GENERAL INFORMATION

REQUESTS FOR INFORMATION:

LOWER POTTS GROVE MUNICIPAL BUILDING & POLICE STATION

A-004

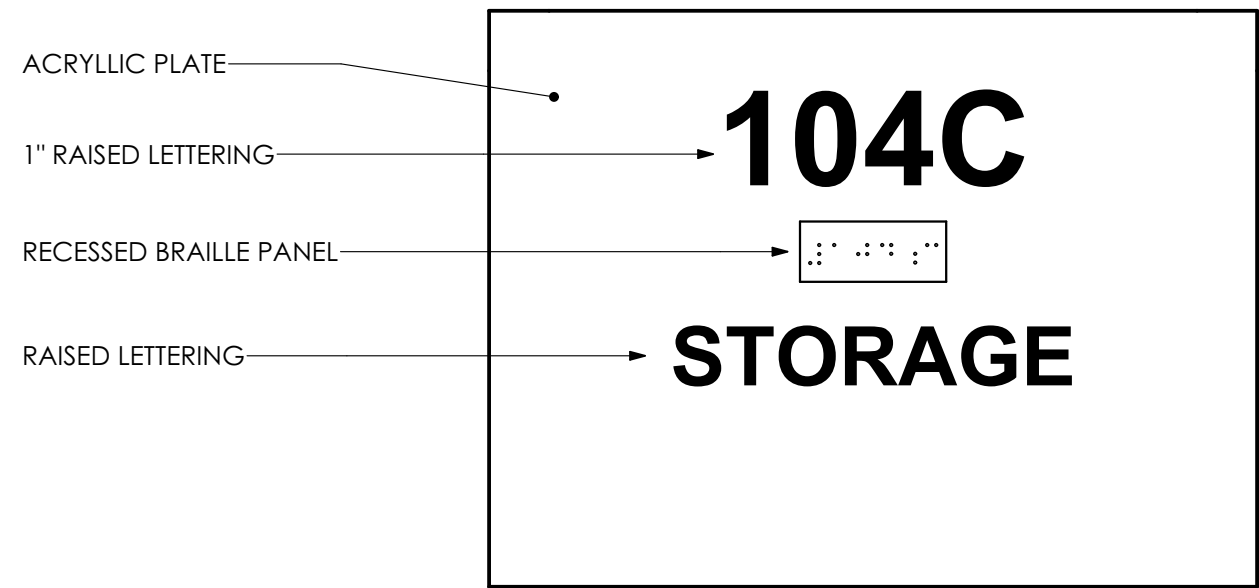
A-003: Signage updates per RFI #78 response.

1. SIGN TYPES C-11 AND C-12 REMOVED. THESE WILL BE INTEGRAL TO THE FIRE EXTINGUISHER CABINETS.
2. SIGNS A.13 & A.15 REMOVED FROM ALL LOCATIONS.

TYPE B.27

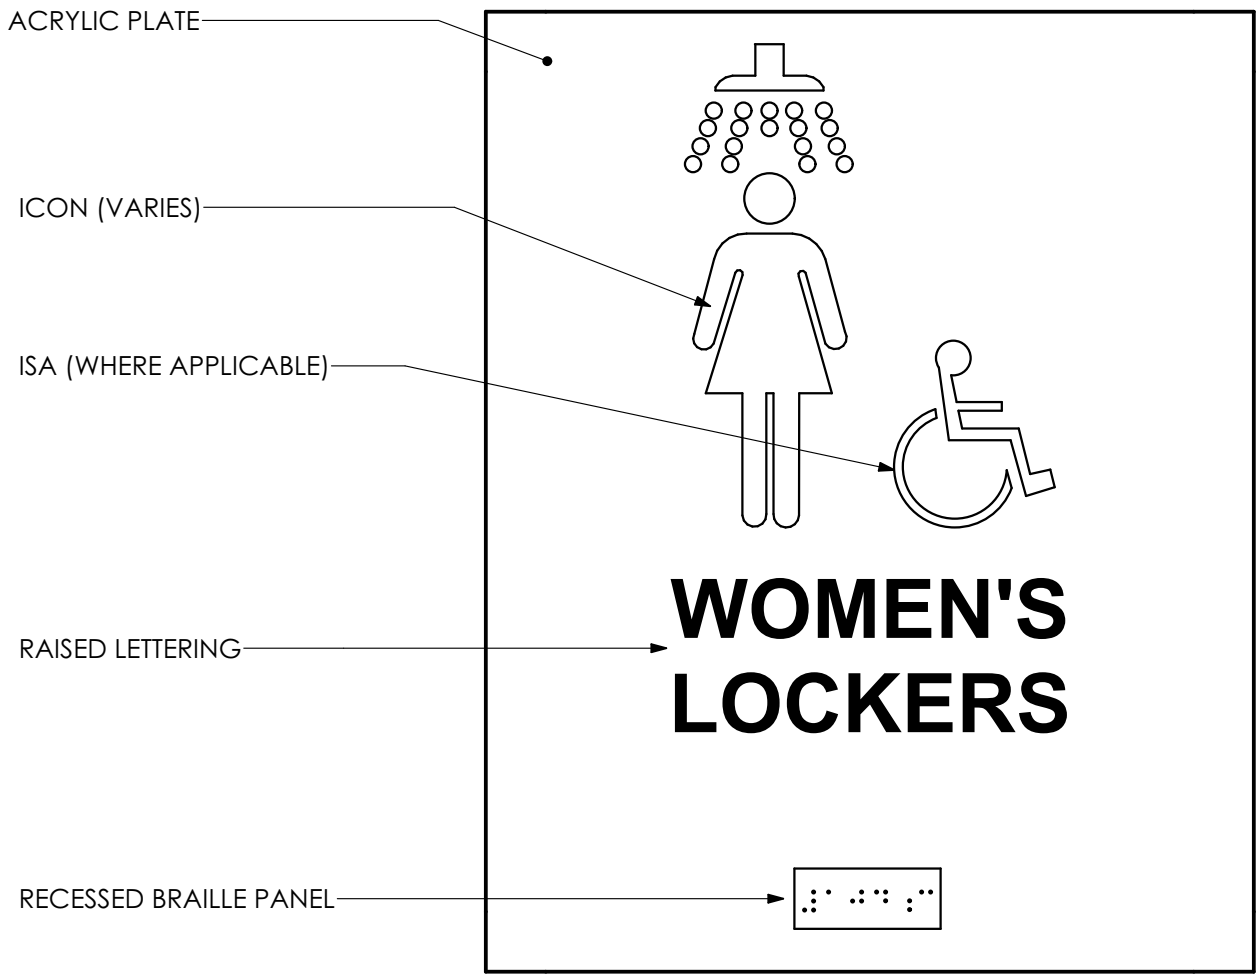
B.27 – Accessible Locker Room – Women: Shown on A-008

TYPE B.26

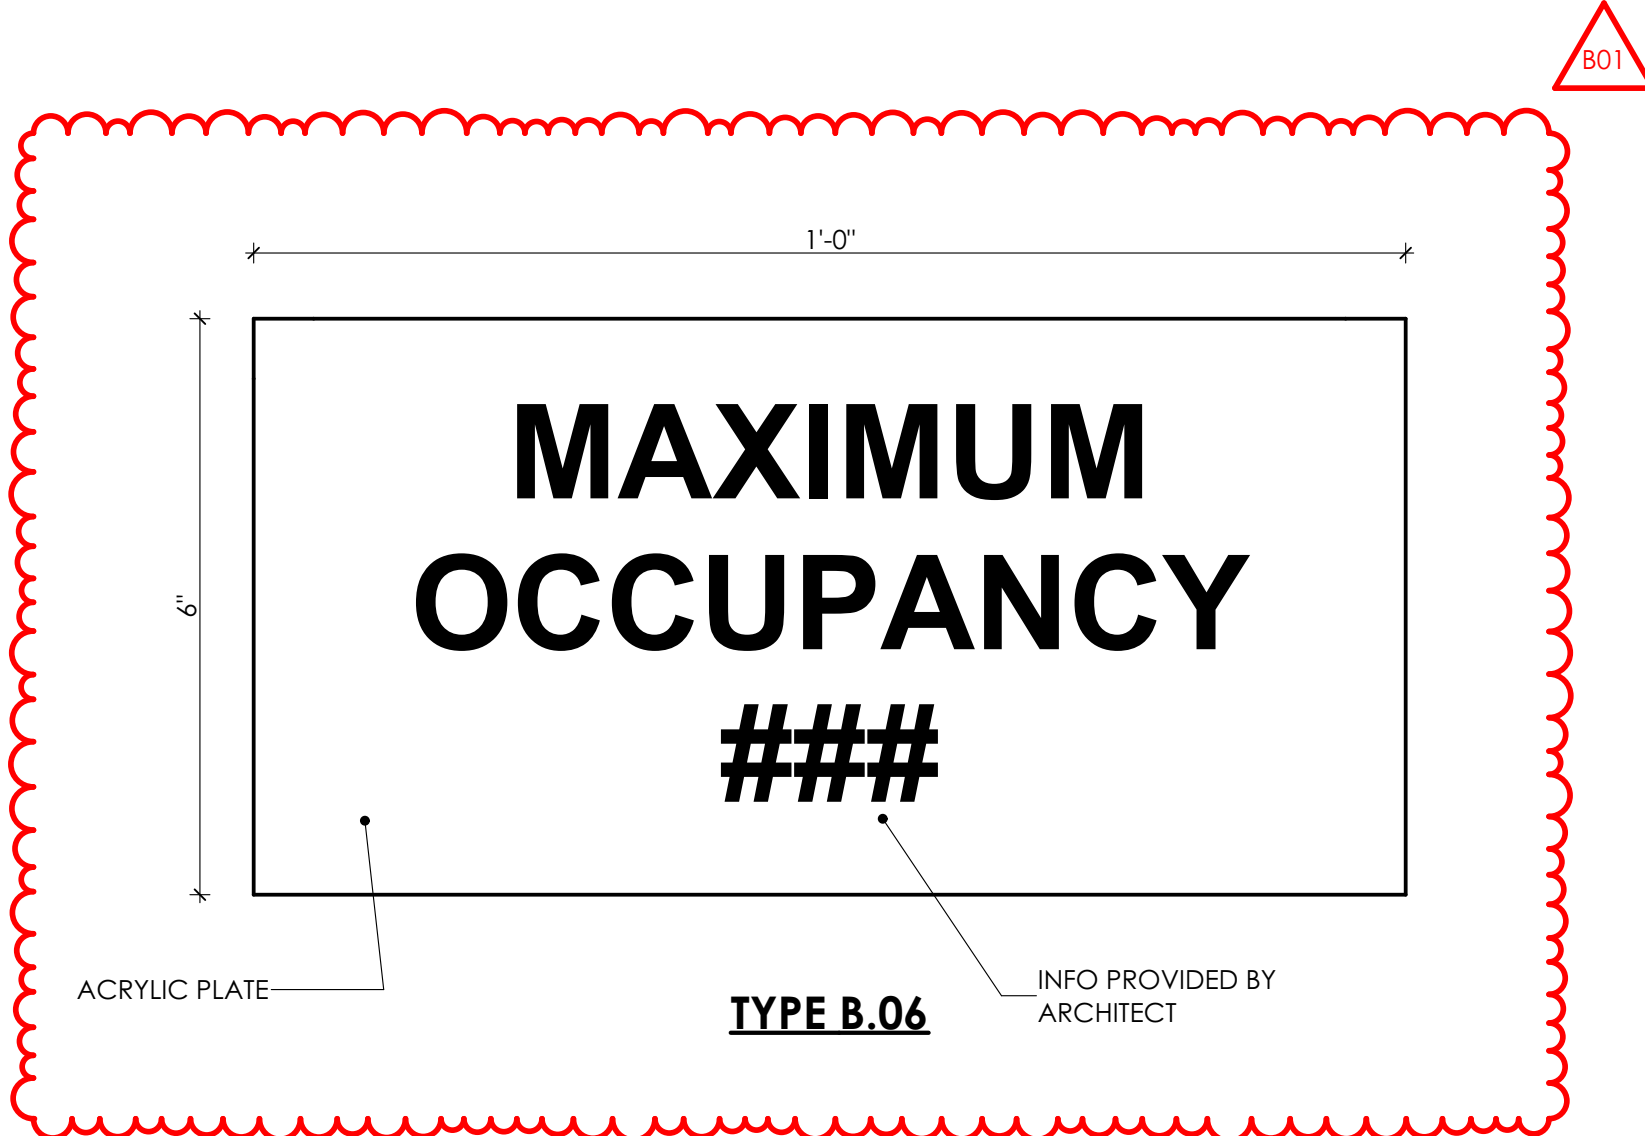
B.26 – Accessible Locker Room – Men: Shown on A-008
